RESOLUTION NO. 4583

**RESOLUTION OF THE CITY COUNCIL OF THE CITY OF WOODLAND
ADOPTING CEQA ADDENDUM #5 TO THE TURN OF THE CENTURY EIR
AND APPROVING AMENDMENT #3 TO THE SPRING LAKE SPECIFIC PLAN**

SUBJECT: Spring Lake Specific Plan Amendment #3 DATE: October 19, 2004

PROJECT TITLE: SPRING LAKE SPECIFIC PLAN AMENDMENTS – Developer Requested Amendments

CHANGE TRAIL TO GREENBELT

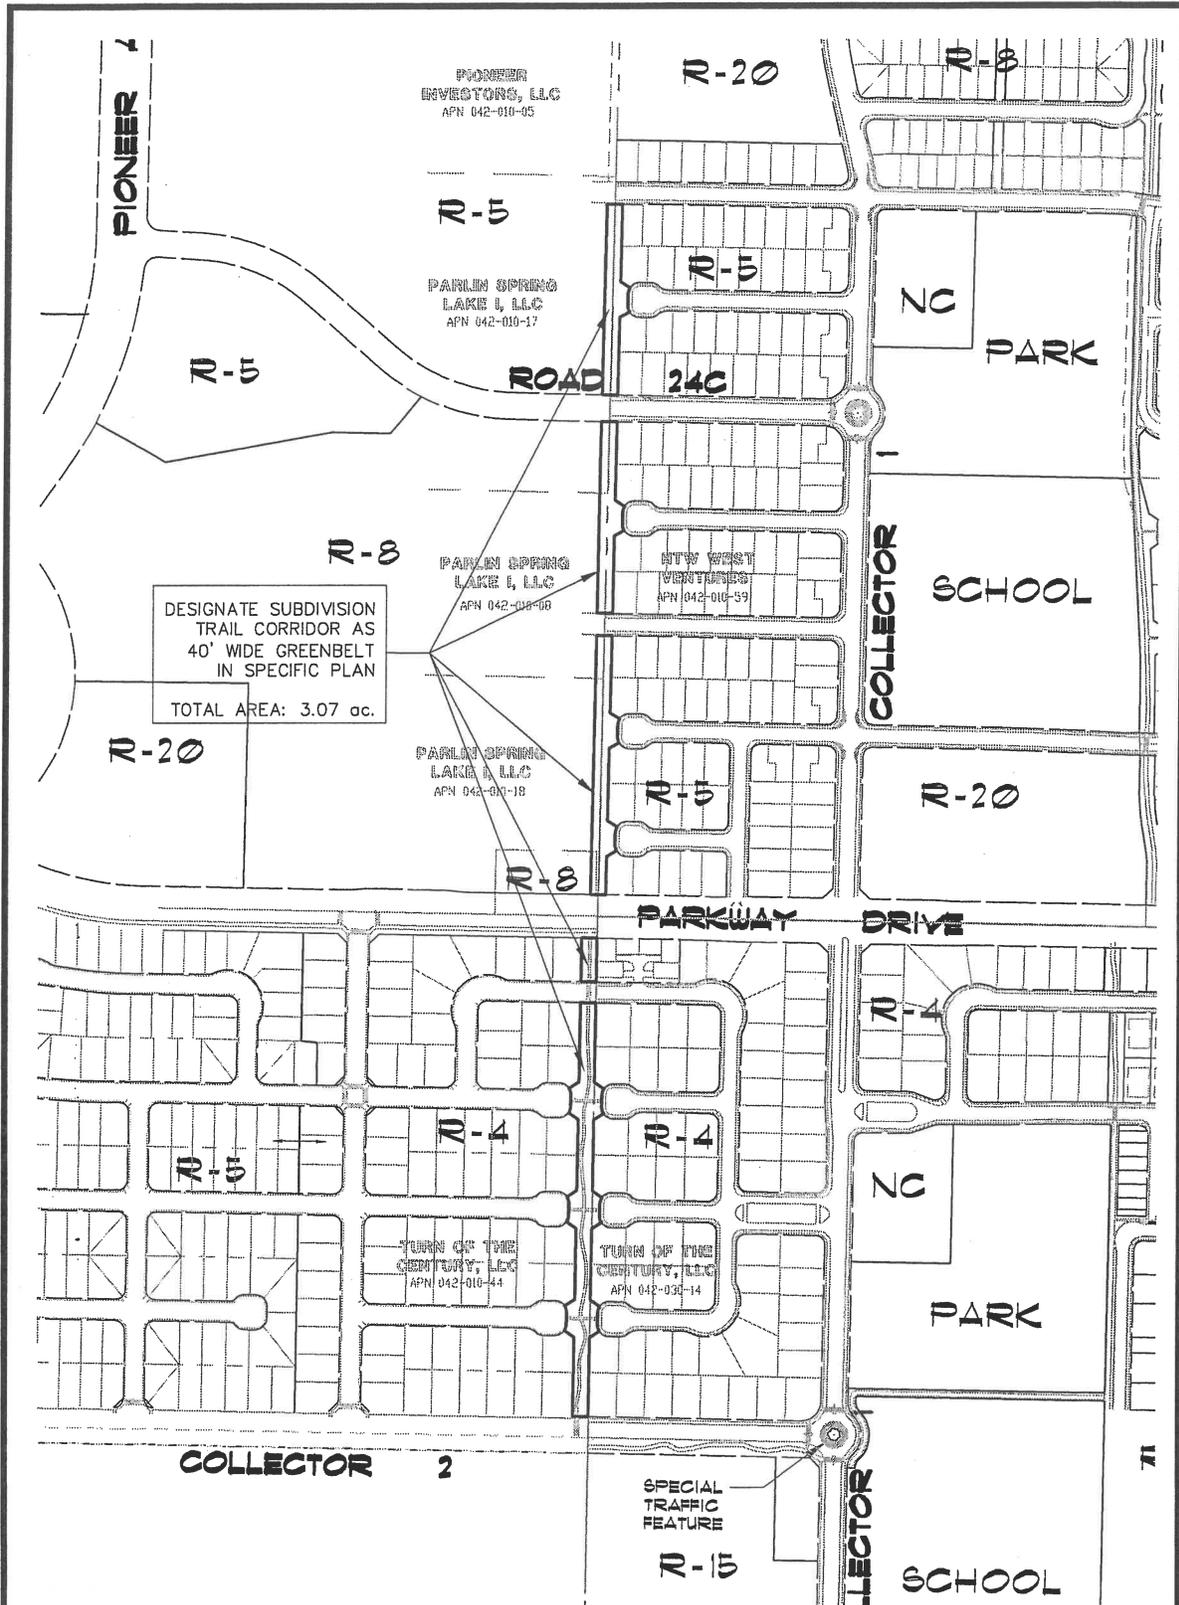
4. Revise the open space trail system to include the 40 foot trail located on the TOC 160, Beeghly, Russell and Hollman/Little parcels as a SLSP “greenbelt.”

Item #4 is supported by staff. The SLSP provides for greenbelt and trail connections to link park facilities, schools and the downtown cultural areas in various locations. With the approval of the TOC 160, Beeghly Ranch, and Russell Ranch projects, the subdivision design proposed an additional 40 foot trail. The amendment proposes to include the additional 40 foot greenbelt (split between the TOC-160 / Hollman / Little properties and the Beeghly /Russell properties) as part the SLSP greenbelt trail system. Attachment 4 provided the location for the proposed greenbelt. The greenbelt will add 3.07 additional acres to the SLSP greenbelt system. The affect being that this greenbelt would become a “plan” area cost for acquisition, design and maintenance; however the trail connection will provide additional pedestrian and bike circulation for the entire plan area. Maintenance for the additional landscape and other amenities has been added to the Landscape and Lighting District proposed for the Spring Lake area.

CR 102
SECTION A-A
 SCALE: 1"=10'

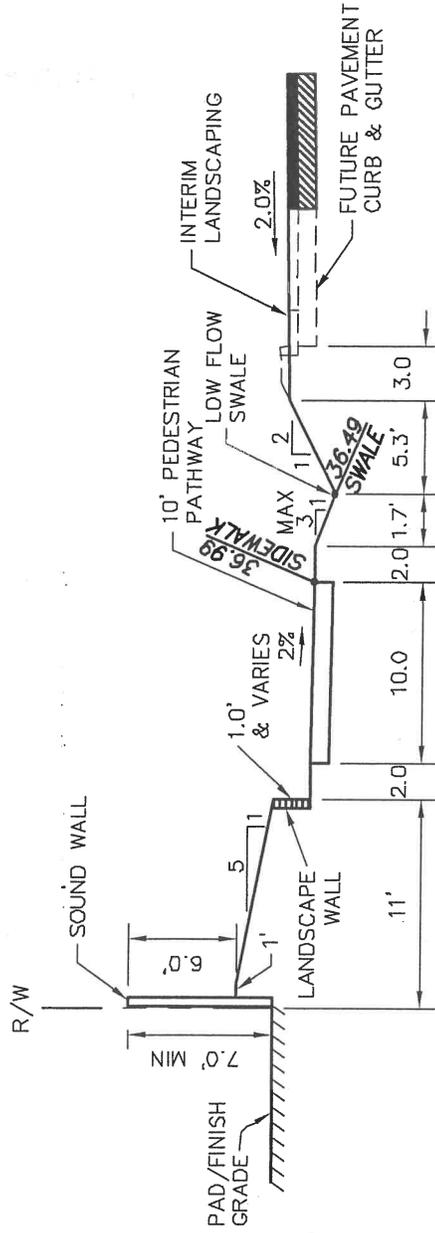
CR 102 is an arterial street and has a planned 35 foot landscape corridor (refer to Attachment 5). The street trees planned for CR 102 include London Plane / Scarlet Oak and Crape Myrtle. In accordance with the SLSP Design Standards primary street trees will be placed 50 feet apart with a secondary street tree in between. The result will provide a large street tree canopy with majestic shape as well as color, variety and accent with trees spaced 25 feet apart. In addition, shrubs and vines will be used to cover and screen at least 50% of the wall within three years.
